## Product/Process Change Notice (PCN)

PCN #: PCN\_IndSL\_20170510

Product Affected: WE-SL series

Old Part                      New Part  
 Picture 1: Top view

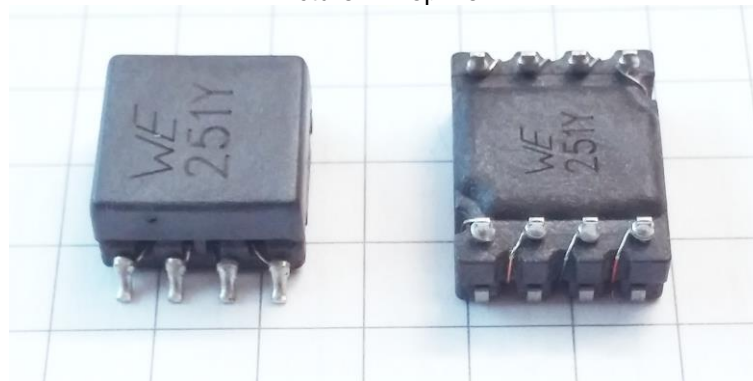
The plastic housing of the component will be changed. The new design consists of a single plastic molded part.
